Re sanctioning the estimated cost for repairing the Aswathanarayanaswamy temple Mahisale in the Shivthakalle Talug.

MUZRAI DEPARTMENT.

Repairing the Sri Mahishi Aswathanarayanaswami temple in the Tirthahalli Taluk.

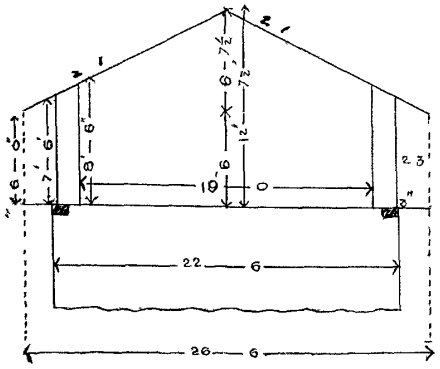
[illegible] of [illegible] of the block. As [illegible] and as no trusses [illegible] to the block, it is proposed [illegible] under [illegible] to insert in the centre of the wall, six broad [illegible] and bring [illegible] of the same rails at a [illegible] couple rafters to rest on. It is still necessary to have each couple [illegible] joined on the [illegible] ground and could have been no doubt, if only couples had been proposed and iron pillars and ridge piece dispensed with. The masonry pillars to embed the rails have been finished and it is not by any means necessary arrangement to fix the ridge and it is too late to remove these. So they have been allowed to stand.

The eave of the roof in the inner courtyard is 9 ft. to top of rafter above floor. This if worked with a 2 to 1 slope usually adopted for country tile roof gives for a 26½ft. span the eave to eave 12'-7½" for the height at ridge. This seems to be a very awkward height for a living room and so to gain height 1½ to 1 slope seems to have been adopted in the sanctioned plan allowing a height of [illegible] at ridge and 6ft. at eave. This slope is no doubt steep for a pan tile roof and would require precautions to prevent slips, but under the circumstances there seems to be no help but to adopt a steep slope keeping the eave height at 6ft.

4. In the rear of the block, a screen wall 1½ broad of laterite brick in chunam is proposed and lattice work for the front between pillars In as much as laterite brick in chunam is not half as strong as stone in chunam owing to want of proper adhesion between mortar and laterite as evidenced in more than one bridge, as these bricks have to be carted from Heddur quarry crossing the river and as labour for this kind of work is not available, and even if available the season is unfavorable, the overseer proposes using burnt stone for the rear screen wall and contractor has agreed to do this work at the rate sanctioned for laterite in chunam (0-4-6) per c.ft. As similar work has been done to the main gate, I have allowed this change of material to keep the work going and prevent dispersion of labour in this difficult locality pending kind sanction of the Superintending Engineer.
